R44 SERVICE BULLETIN SB-106

R66 SERVICE BULLETIN SB-37

SUBJECT: HeliSAS Autopilot Interface with Garmin PFD

FIGURE 1

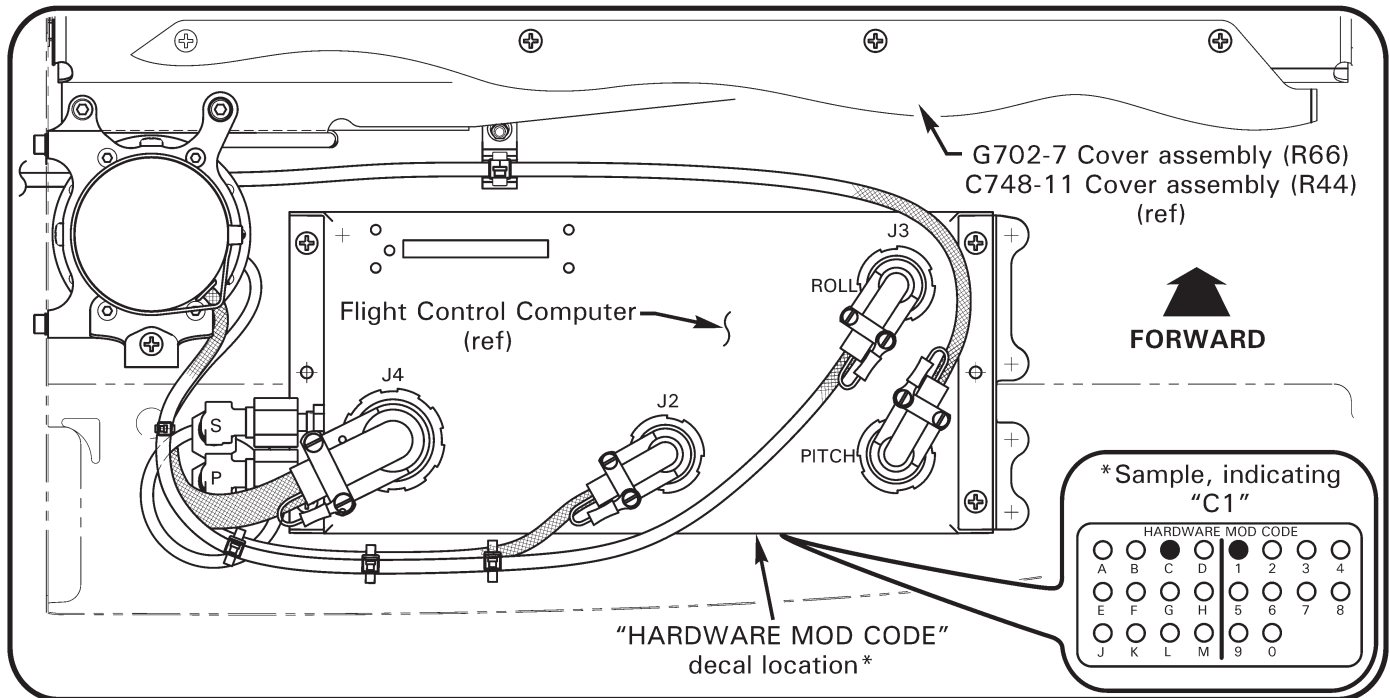
- FCC modification at S-TEC requires approximately 2 weeks.
- Modification level of upgraded unit will be indicated on data plate as shown in Figure 1.
